# UNITED STATES PATENT AND TRADEMARK OFFICE

| APPLICATION NO. | FILING DATE | FIRST NAMED INVENTOR | ATTORNEY DOCKET NO. | CONFIRMATION NO. |
|-----------------|-------------|----------------------|---------------------|------------------|
| 10/791,589      | 03/02/2004  | Glenn Klecker        | DBH:0756.0840       | 3452             |

| <b>Office Action Summary</b> | <b>Application No.</b><br>10/791,589 | <b>Applicant(s)</b><br>KLECKER ET AL. |  |

## **DETAILED ACTION**

Diagram 1. Figure 9 of Berg is shown above in the extended, operative position.

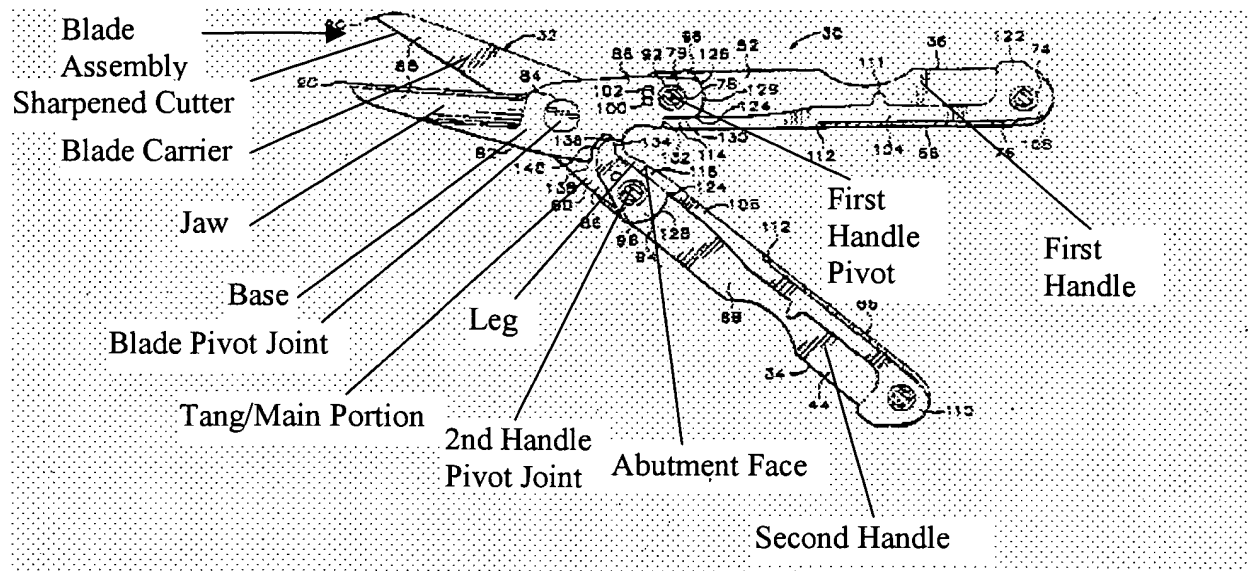
and Rose et al (5,621,974), hereafter Rose. Berg discloses everything as noted in Diagram 1 below, and discloses a spring that urges the jaw and the blade assembly to pivot apart from each other about the pivot joint as recited in columns 5 through 6, lines 63 through 7, respectively.

Berg does not disclose a cavity surrounding the blade pivot joint, a groove extending away from the cavity, a spring located within the cavity, the spring having a pair of opposite ends extending from the cavity to the second handle pivot joint and engaged with the tang of the blade carrier.

However, Mizutani teaches cavity 5, 6 surrounding the blade pivot joint 17, a groove 11, 12 extending away from the cavity, a spring 13 located within the cavity, the spring having a pair of opposite ends 16 extending from the cavity to the second handle pivot joint and engaged with the tang 7, 8 of the blade carrier. It would have been obvious to provide a cavity surrounding the blade pivot joint, a groove extending away from the cavity, a spring located within the cavity, the spring having a pair of opposite ends extending from the cavity to the second handle pivot joint and engaged with the tang of the blade carrier in Berg as taught by Mizutani in order to enclose the mechanism that urges the jaw and blade assembly to pivot apart from each other and protect it from dust and debris.

Berg also does not disclose a removably mounted, sharpened cutter on the blade carrier. However, Rose teaches a removably mounted, sharpened cutter 20. It would have been obvious to provide a removably mounted, sharpened cutter in Berg as taught by James in order to change the sharpened cutter depending on the type of material that is being cut.

6. Claims 20, 21 and 23-27 are rejected under 35 U.S.C. 103(a) as being unpatentable over Berg in view of Eklind (6,151,999). Berg discloses everything as noted above in Diagram 1, and discloses channels 44, 52; side walls 68; base 66, 106. Berg does not disclose cushioning portions of elastomeric material overmolded onto the side walls covering at least part of a respective margin of each of the side walls, and does not disclose a shell layer of a rigid plastics material. However, Eklind teaches cushioning portions 46 of elastomeric material overmolded onto the side walls covering at least part of a respective margin of each of the side walls as shown in figures 5 and 8 and recited in columns 2 through 3, lines 53-3, respectively; and teaches shell layer 12 of a rigid plastics material in column 2, line 29. It would have been obvious to provide cushioning portions of elastomeric material overmolded onto the side walls covering at least part of a respective margin of each of the side walls in Berg as taught by Eklind in order to provide a comfortable gripping surface for the hand of the user. Moreover, it would

7. Claim 22 is rejected under 35 U.S.C. 103(a) as being unpatentable over Berg in view of Mizutani. Berg discloses everything as noted in Diagram 1 below, and discloses a spring that urges the jaw and the blade assembly to pivot apart from each other about the pivot joint as recited in columns 5 through 6, lines 63 through 7, respectively. Berg does not disclose a cavity surrounding the blade pivot joint, a groove extending away from the cavity, a spring located within the cavity, the spring having a pair of opposite ends extending from the cavity to the second handle pivot joint and engaged with the tang of the blade carrier. However, Mizutani teaches cavity 5, 6 surrounding the blade pivot joint 17, a groove 11, 12 extending away from the cavity, a spring 13 located within the cavity, the spring having a pair of opposite ends 16 extending from the cavity to the second handle pivot joint and engaged with the tang 7, 8 of the blade carrier. It would have been obvious to provide a cavity surrounding the blade pivot joint, a groove extending away from the cavity, a spring located within the cavity, the spring having a pair of opposite ends extending from the cavity to the second handle pivot joint and engaged
